# SERVICE BULLETIN

<b>SERVICE BULLETIN</b>		No.: MSB-97E37-001							
		Date: 1997-07-15

<Model>	<M/Y>	COLT(CJ0A)	96-10	LANCER(CK0A)	96-10
<Model>	<M/Y>								
COLT(CJ0A)	96-10								
LANCER(CK0A)	96-10								
Subject: CHANGE IN POWER STEERING HOSE PIPING									
Group: STEERING	Draftno: 96-TA-019								
INFORMATION	OVERSEAS SERVICE DEPT	 R. USAMI - MANAGER QUALITY INFORMATION ANALYSIS

**POWER STEERING HOSES  
REMOVAL AND INSTALLATION**

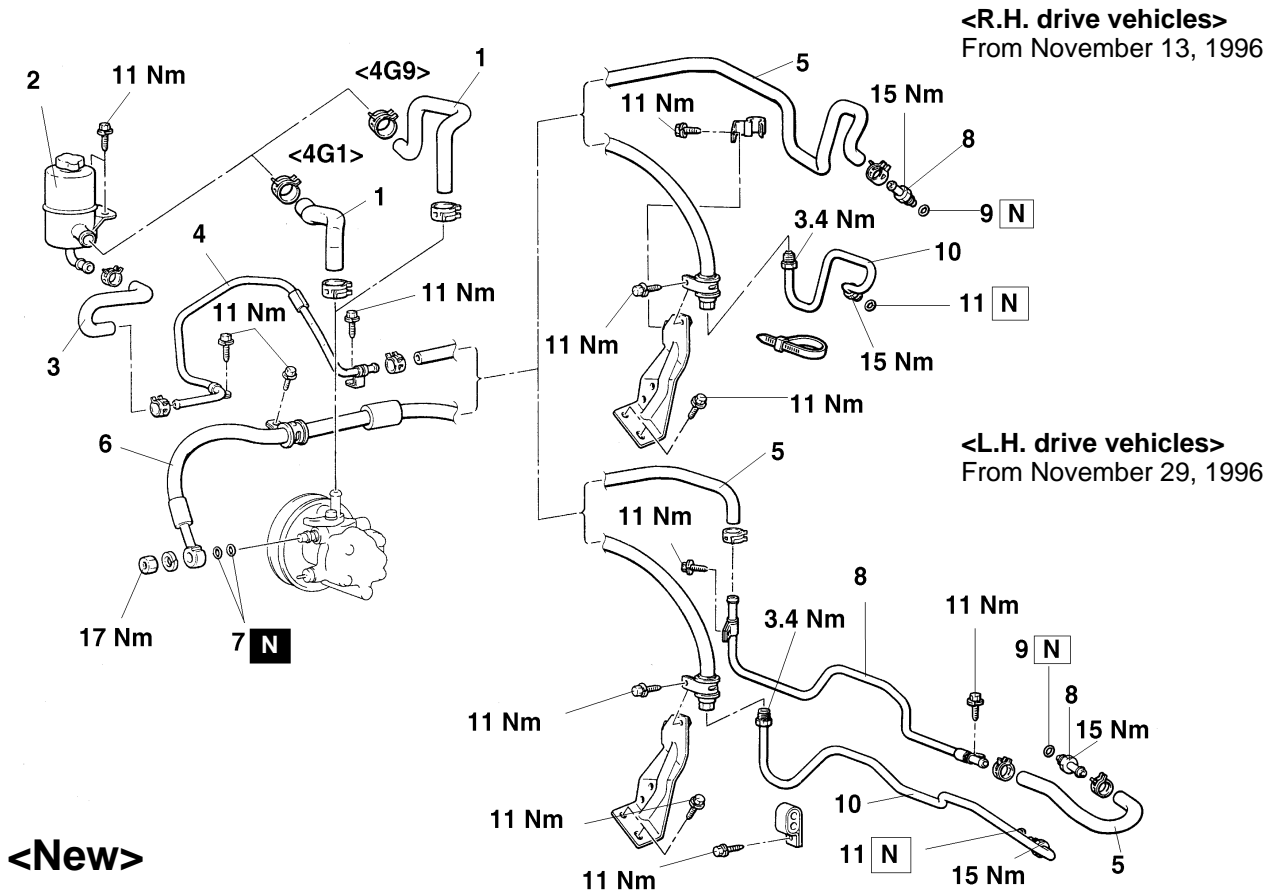
This Service Bulletin informs you of changes in the power steering hose piping.
